Comment Response Letter

Project Name: Alworth

Project Log Number: DSRFY2024-0003

The following in response to the Draft Staff Report dated December 27, 2023. Highlights are from the Staff Report.

A100A

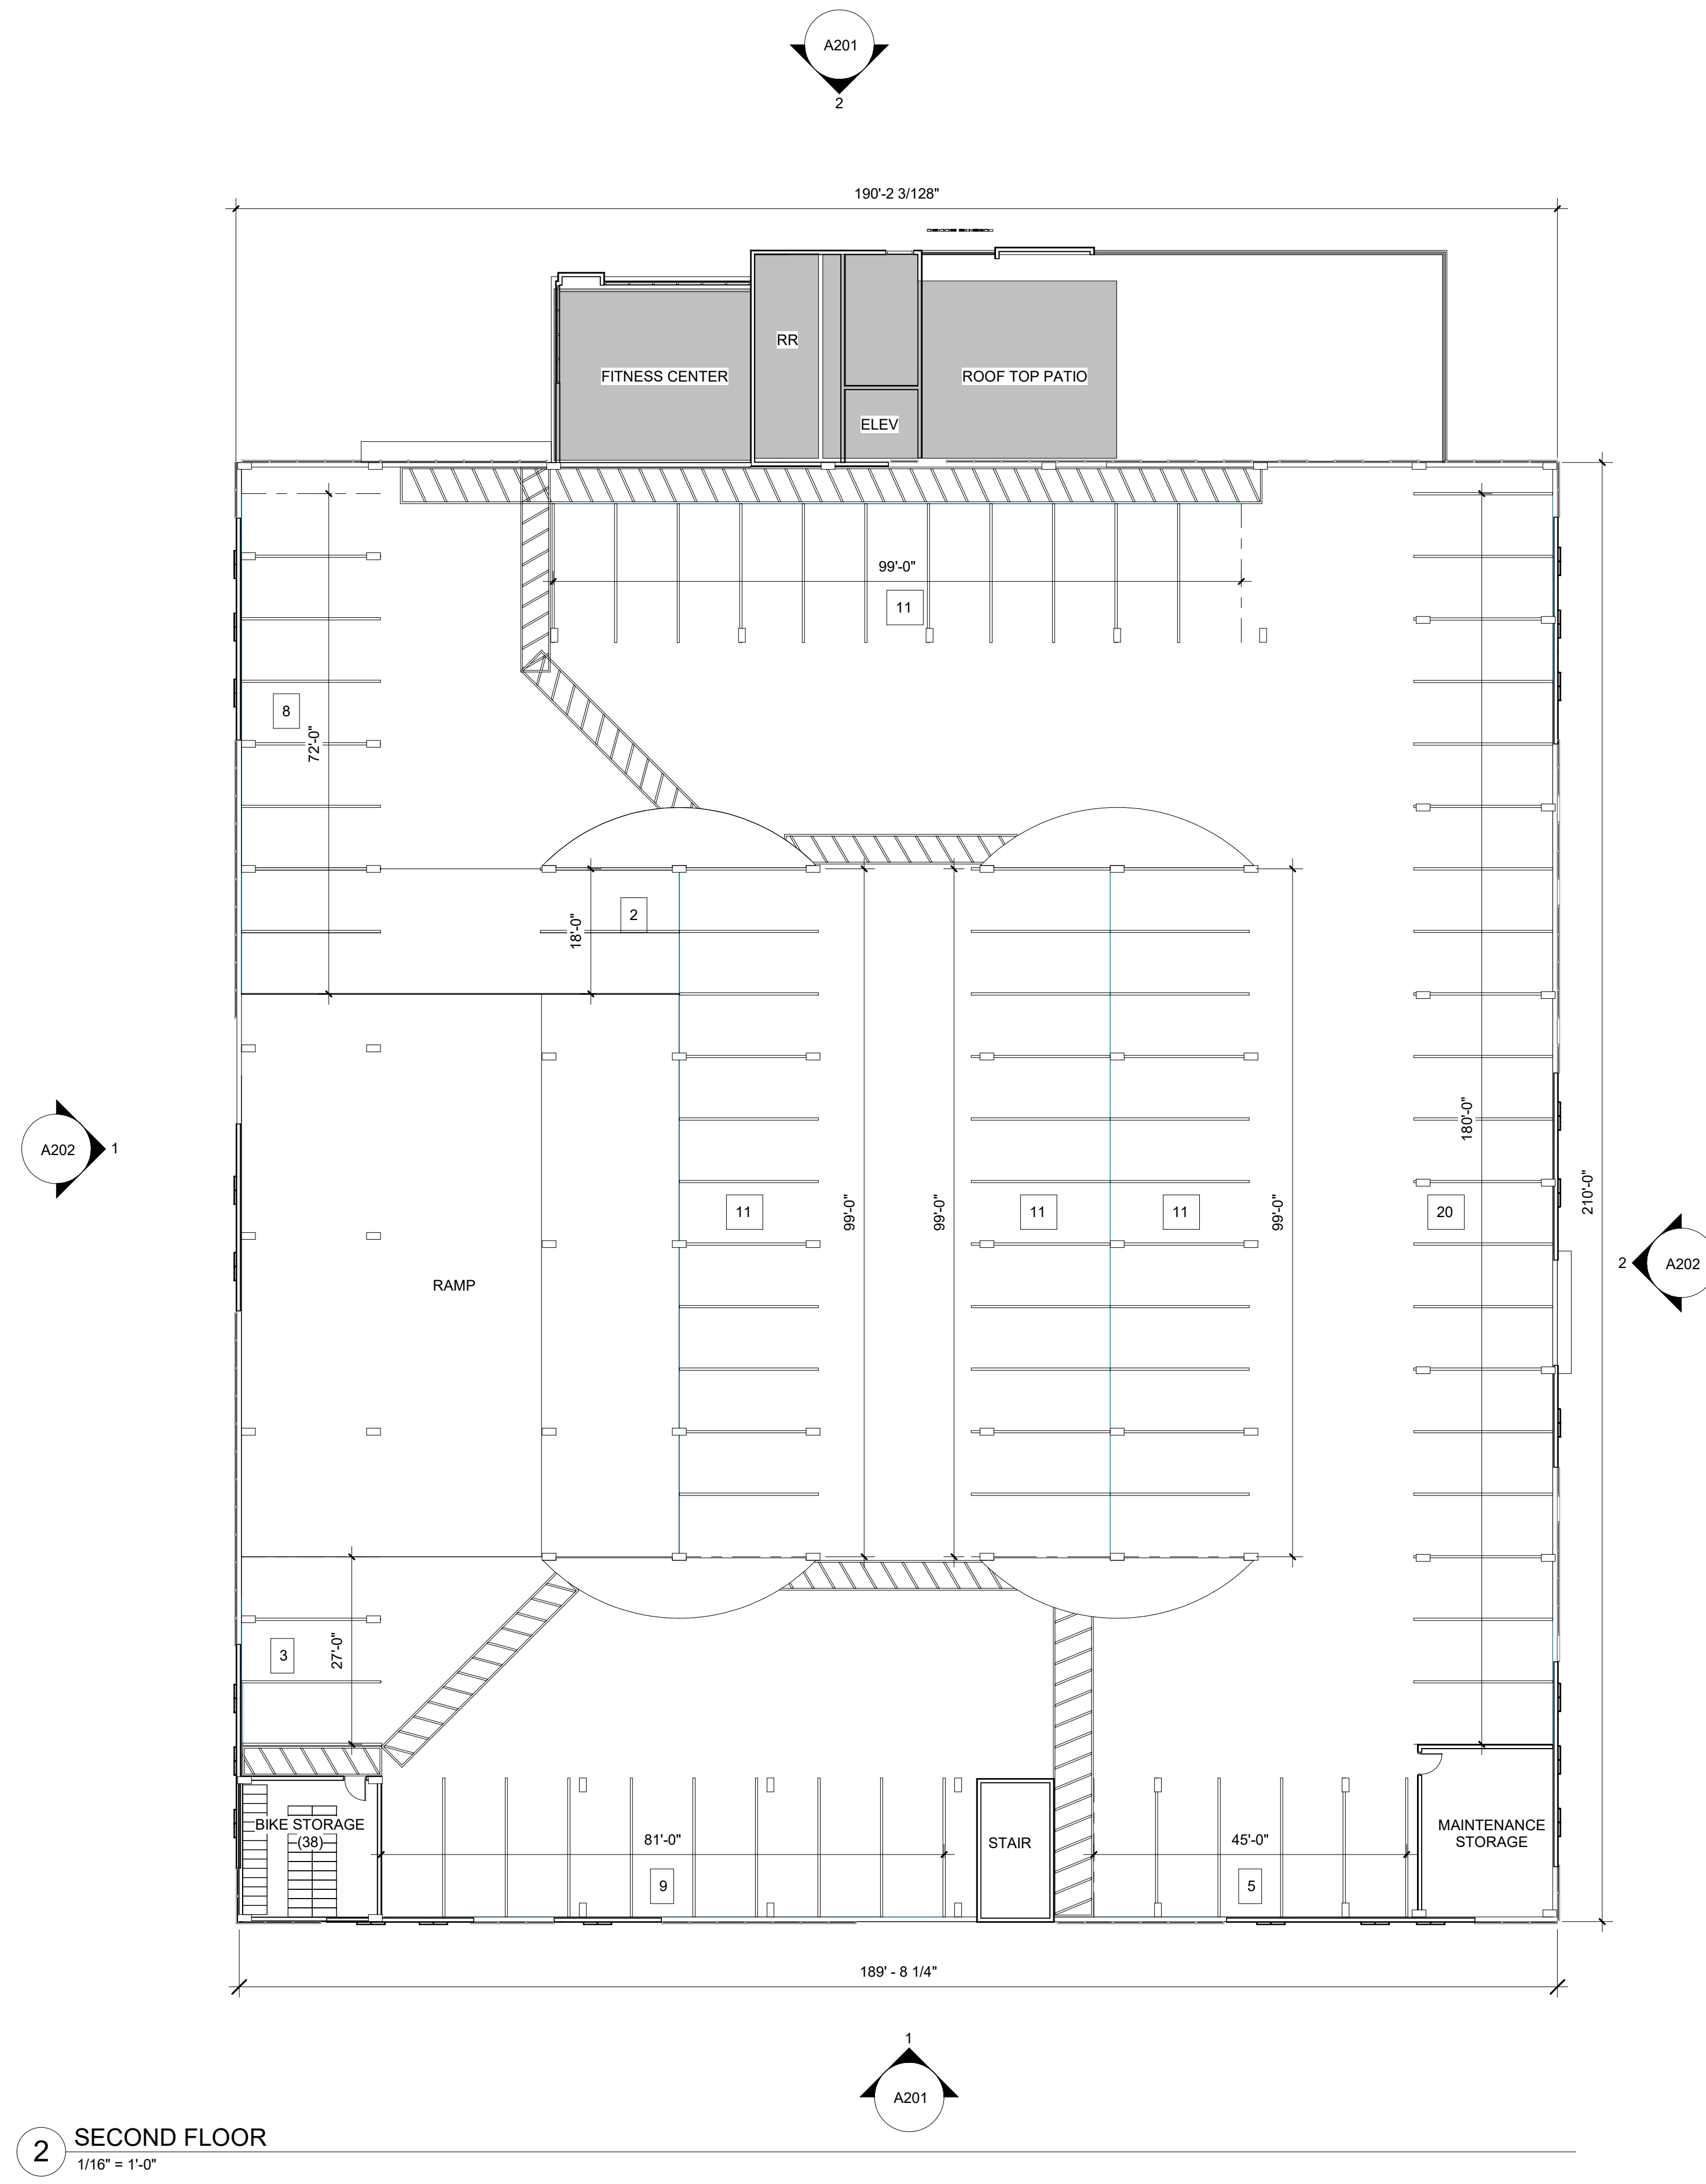
- b. Information mismatch between plans. In plan L100, a pedestrian path is indicated on the western side, while plan A100A does not indicate that there is a pedestrian connection there. In addition, Plan A100A indicates that there is no pedestrian connection within the site on the east side and is only via the sidewalk.

Response: A walkway is not provided on the west side of the building, refer to updated landscape plans. The land on the east side of the property is owned by the city and thus the pedestrian connections are minimal.

FIRST AND SECOND FLOOR PLAN
A101
11/20/24 4:48:05 PM

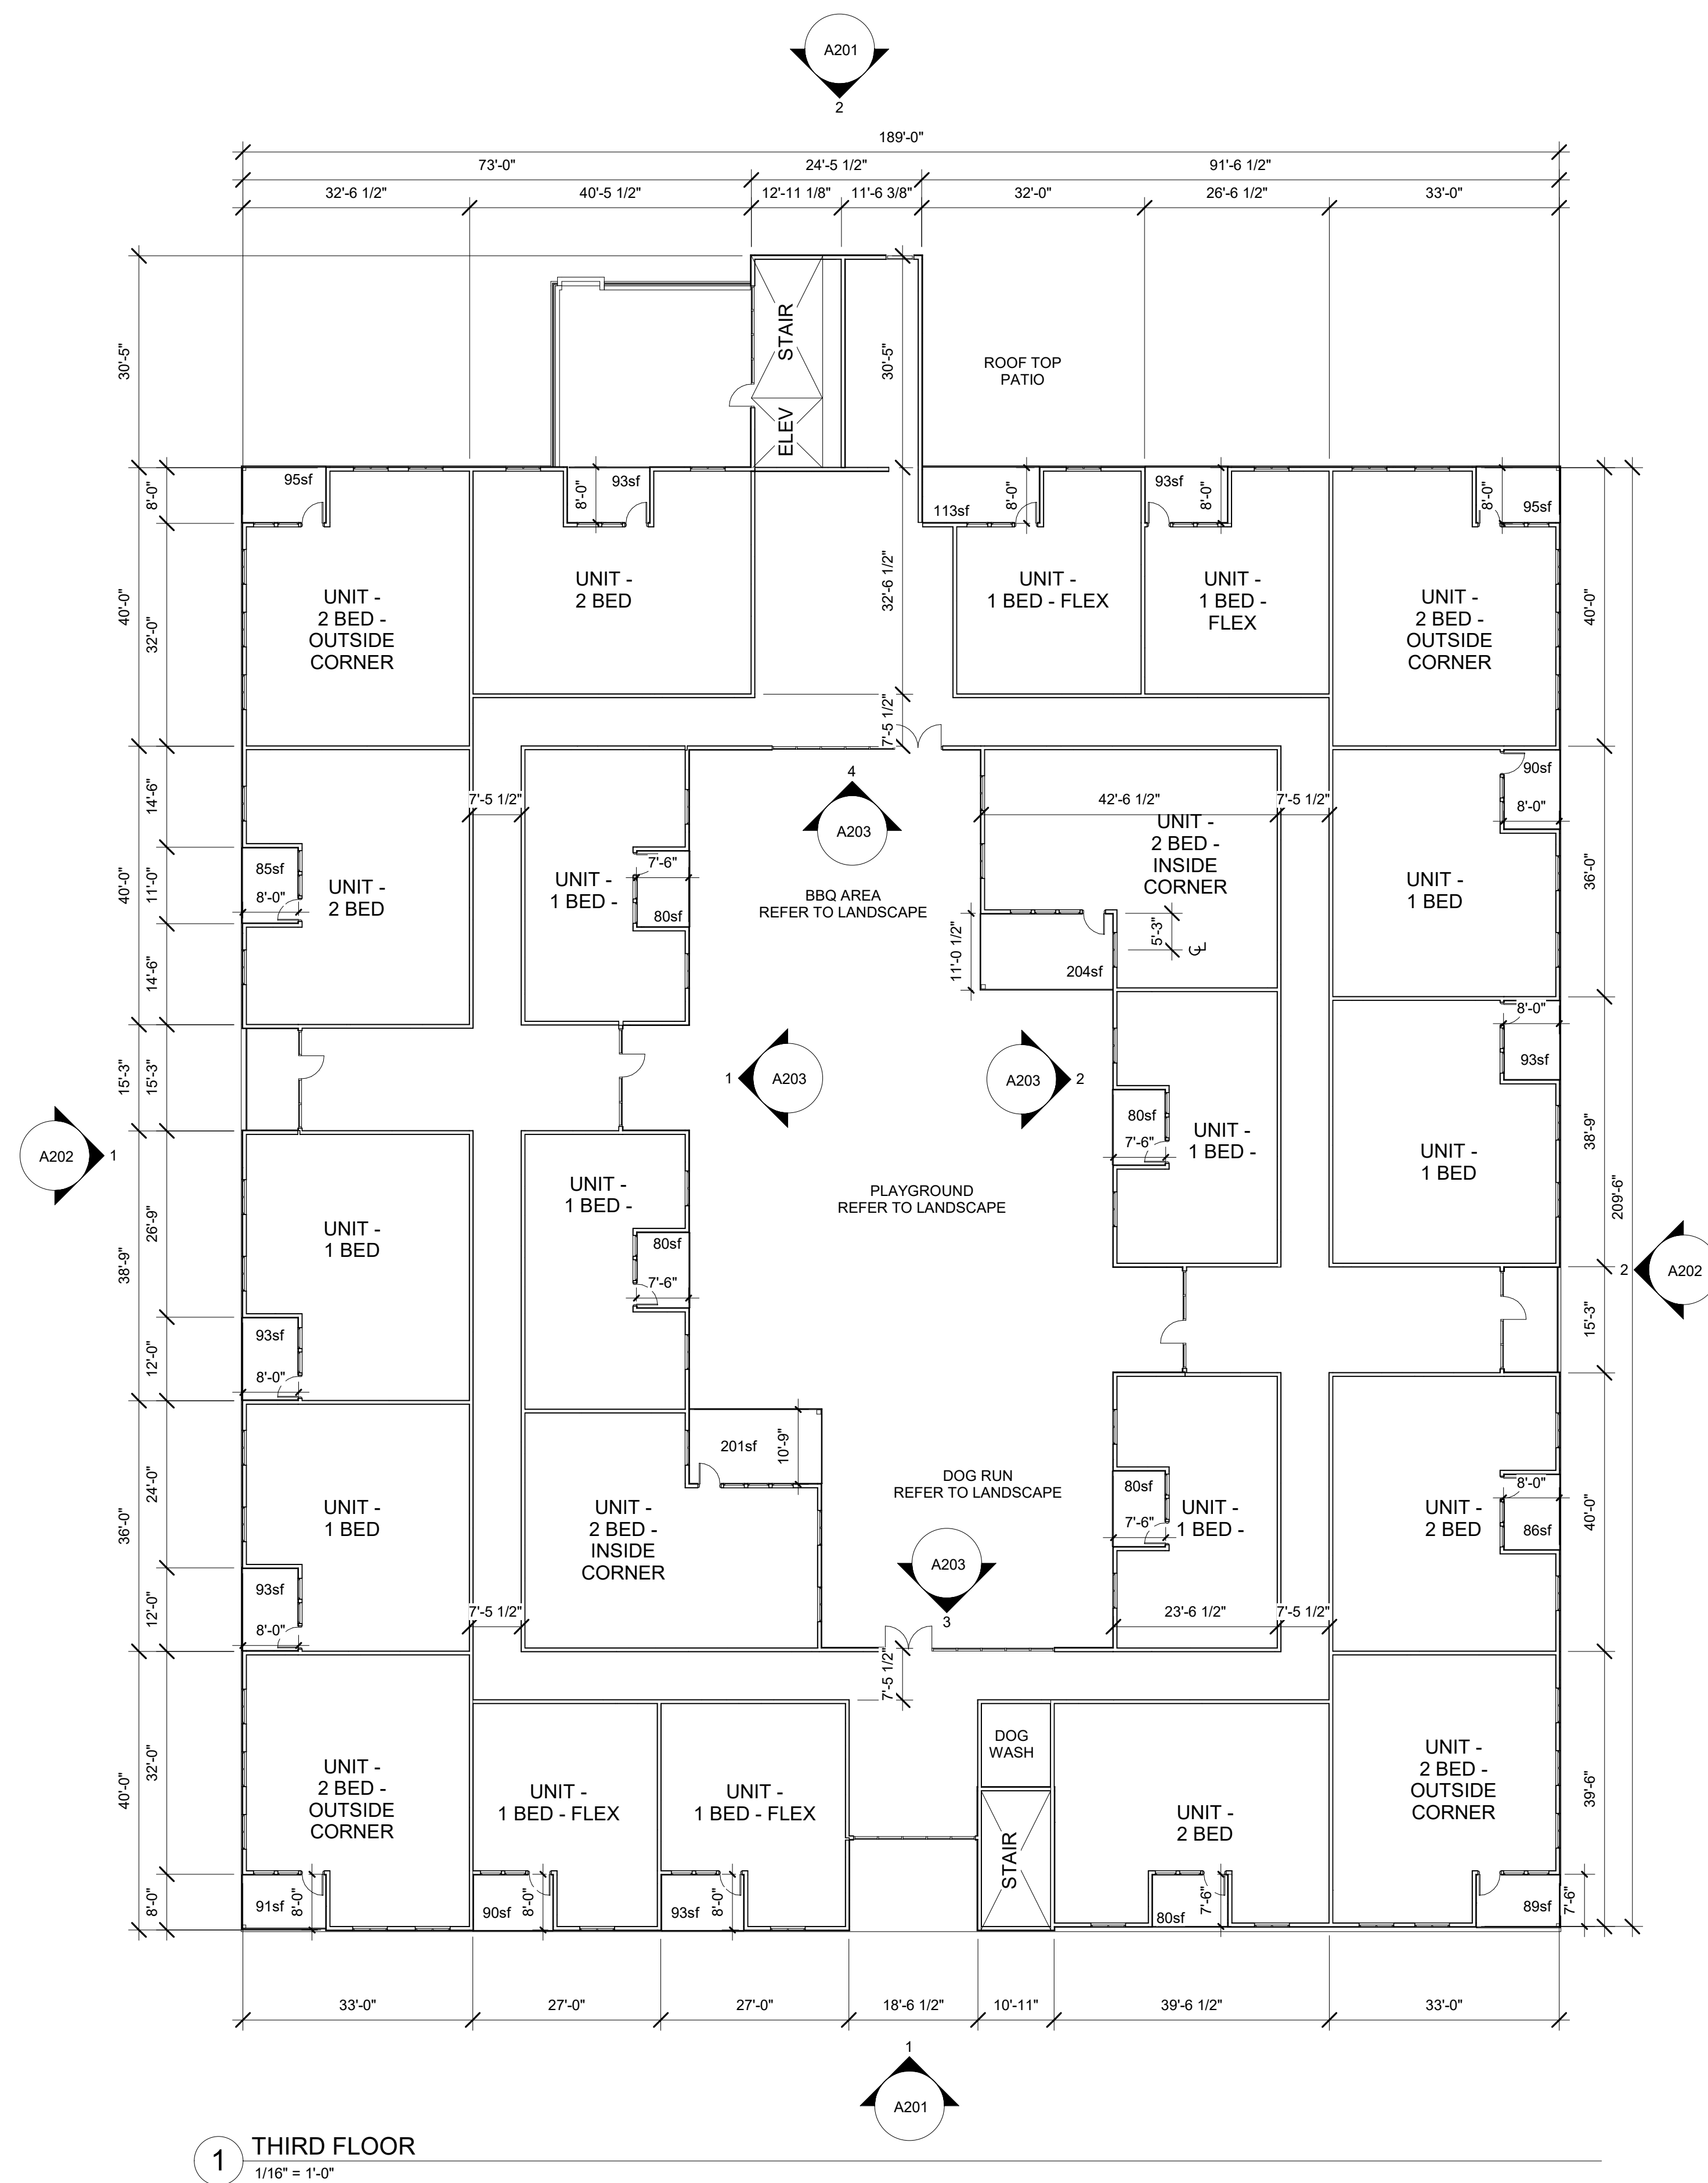
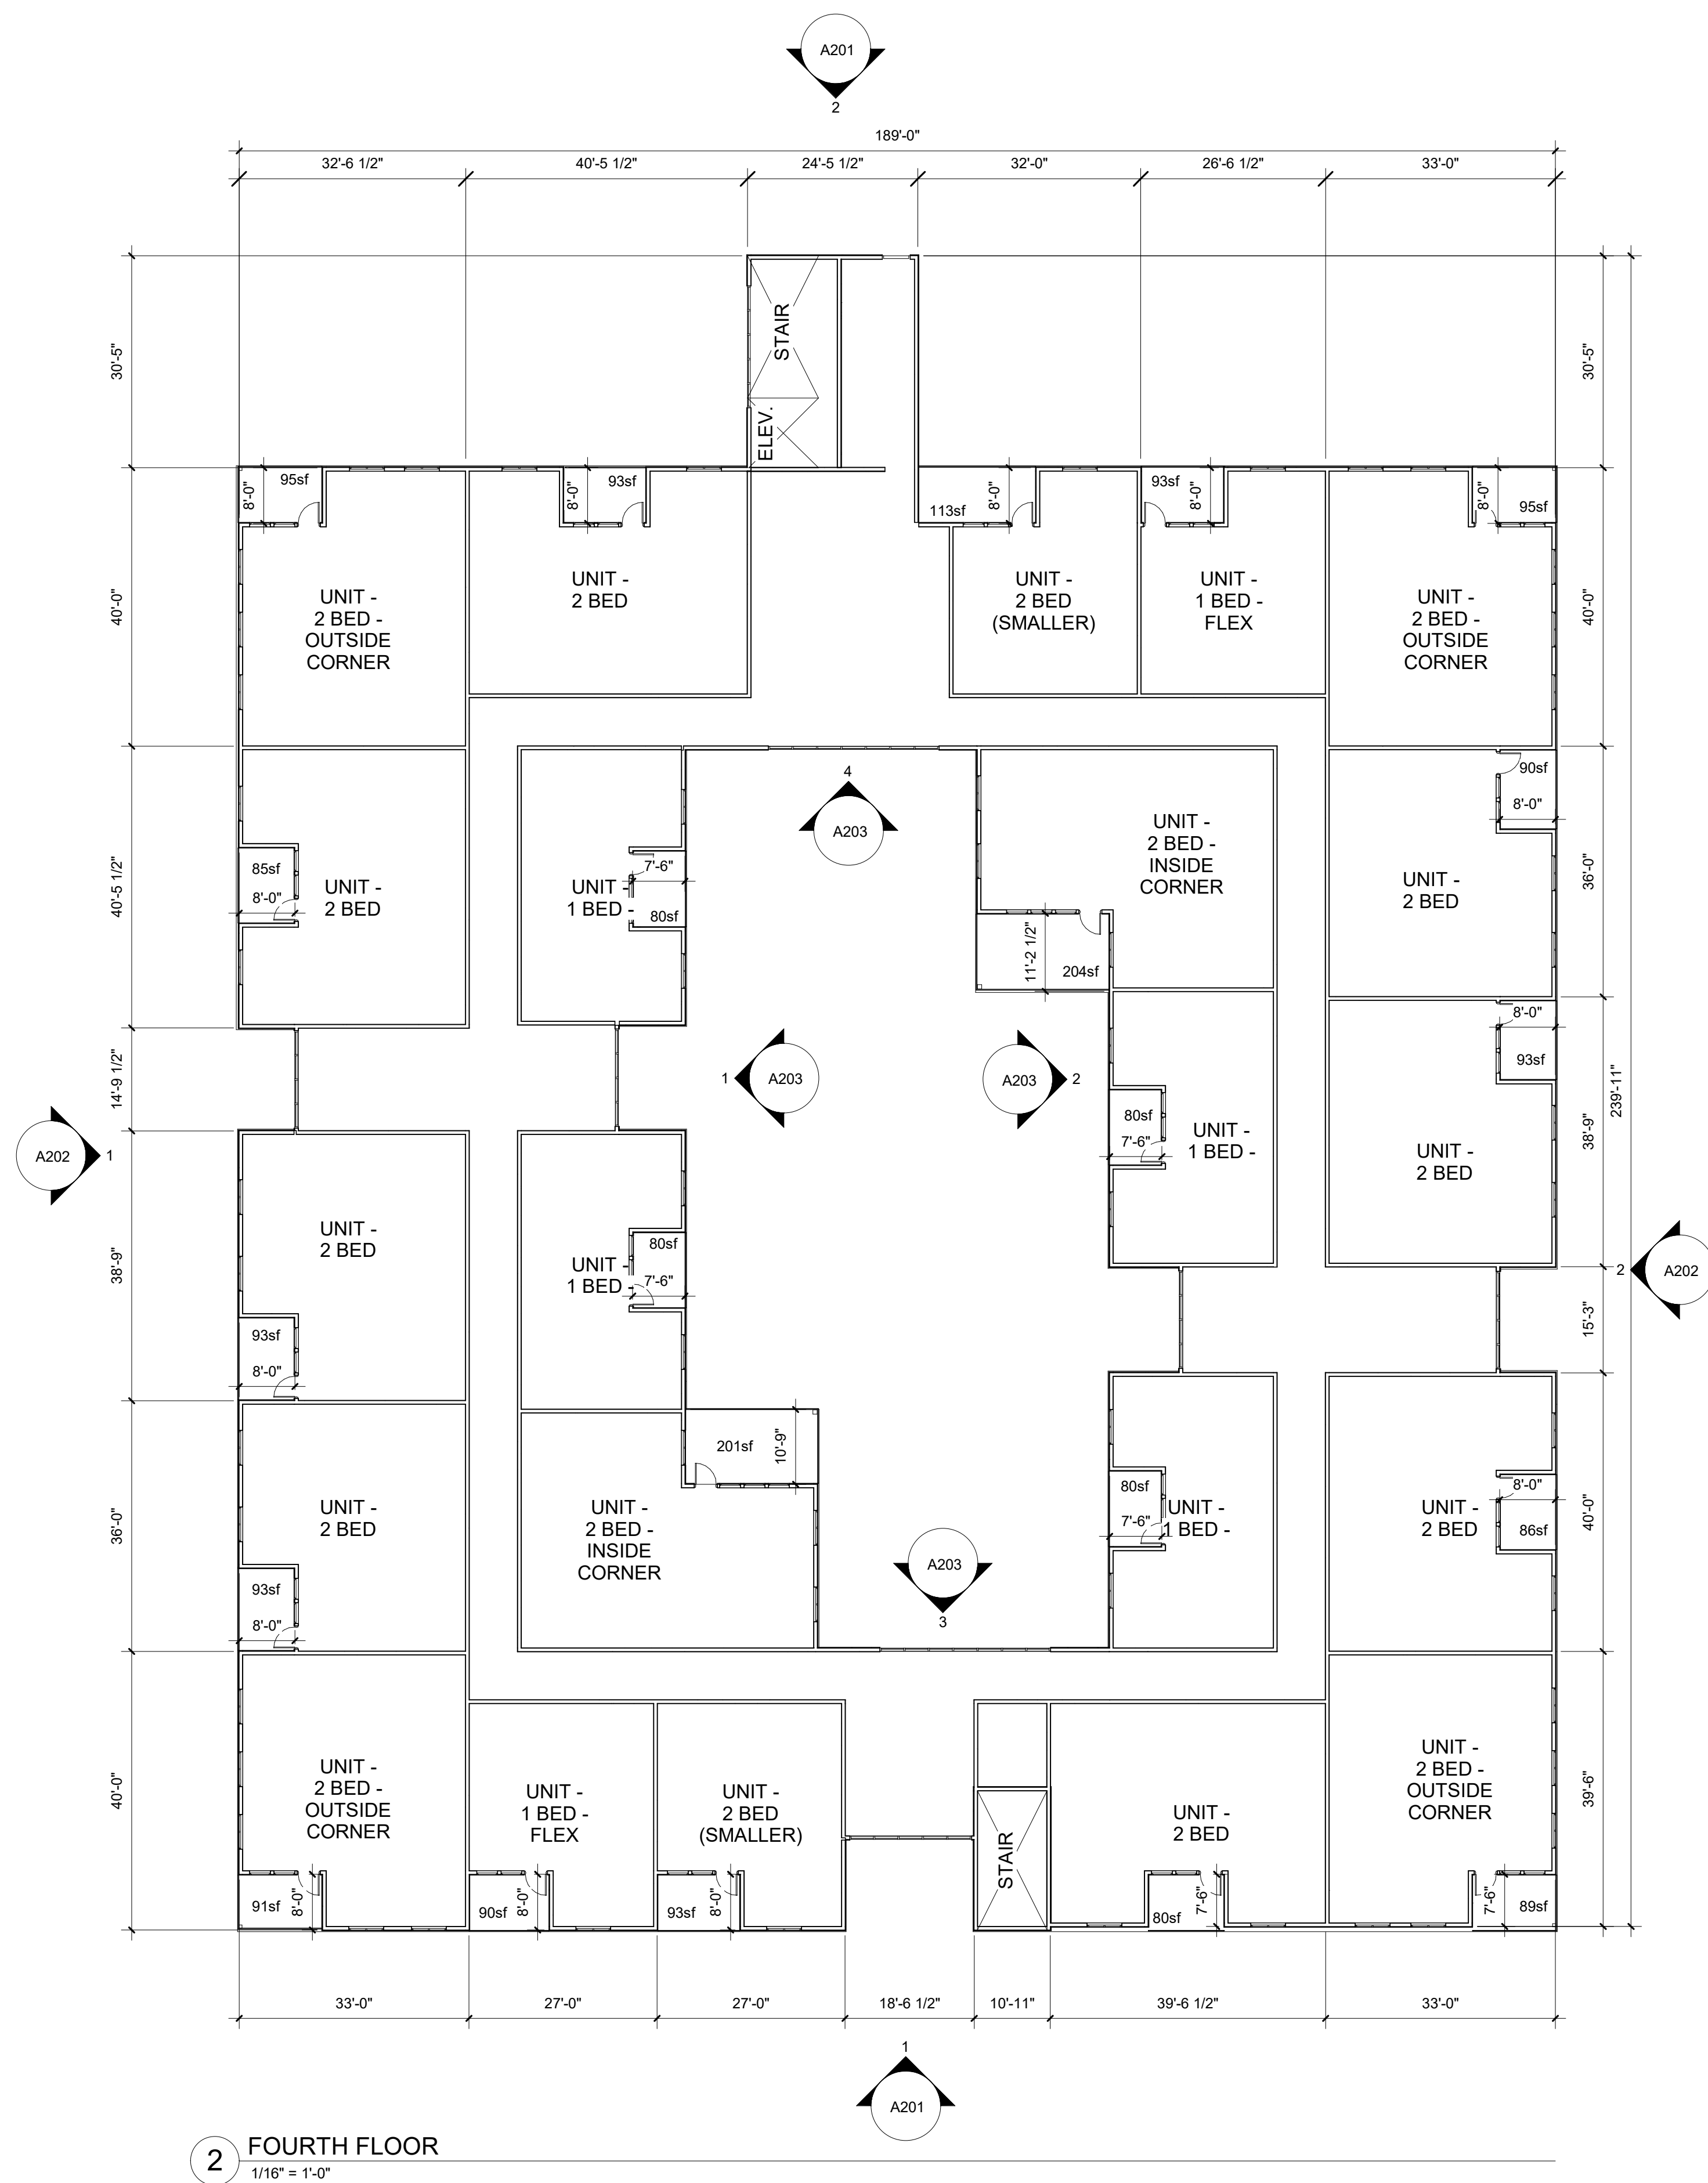
- b. Main entrances, which are the primary point(s) of entry where the majority of building users will enter and leave, shall be designed as an obvious entrance and focal point of the building through architectural treatment, lighting, and address identification. **Design Review Consultant's provided comments. The building does not appear to have a prominent enough main entrance.**

Previously provided comments: Refer to A101, the leasing office space was intended to serve as both a tenant lobby and space for leasing office. The terminology has been updated to reflect this in the plans.
